RE: City of Augusta Drainage issue at the Industrial Park just north of US-54/US-400

INDUSTRIAL PARK DRAINAGE STUDY

REFERENCE: US-54/400 in Butler County

SUBJECT: Drainage Study Review

Google Earth aerial from 1985

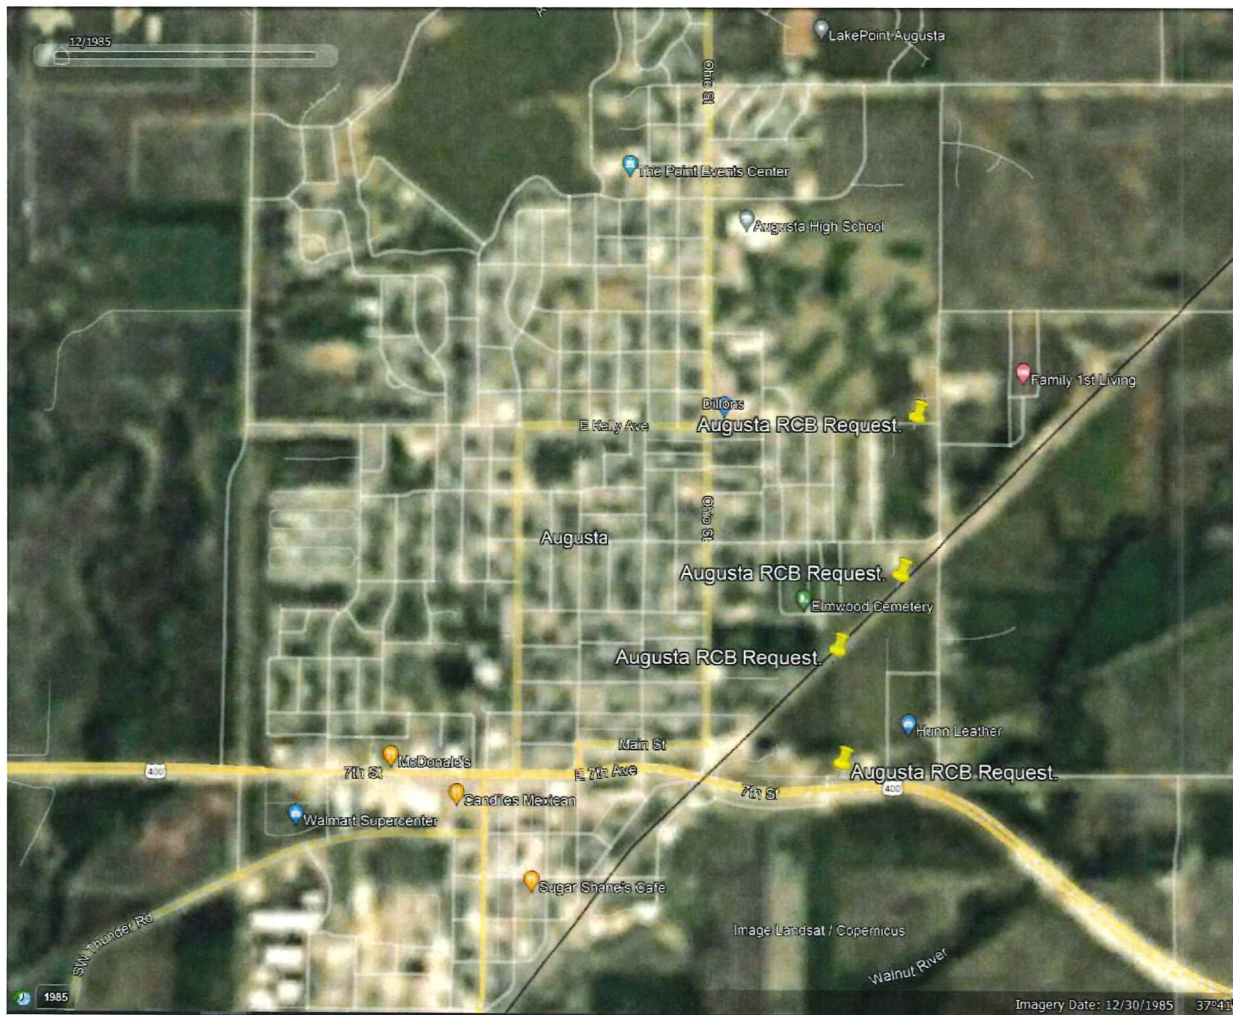
There have been some developments in this drainage basin since 1985, as seen on the below Google Aerial photos. It is unknown what developments were in this basin in 1975. The approximately 77 acres in the triangular area bound by the railroad, 7th Avenue, and Custer Lane in 1985, see Google Earth aerial below, only shows minimal development as compared to the development shown in the 2021 Google Earth aerial below. Several smaller developments can also be seen in the below aerials. It is unknown if these developments had any drainage requirements associated with their building permits.

Since the existing drainage patterns have remained the same and this structure has been in place since the 1970's with no historical issues related to US-54/400, KDOT would not typically change the configuration due to the belief that the flooding issue is caused by developments.

It is KDOT's conclusion that the developments in this drainage basin should have been required to regulate their runoff and should have been required to set building elevation to avoided being flooded. If additional information is available showing that the developments in this drainage basin were required to regulate their runoff, KDOT would re-evaluate this location and issue a new conclusion based on the new information.
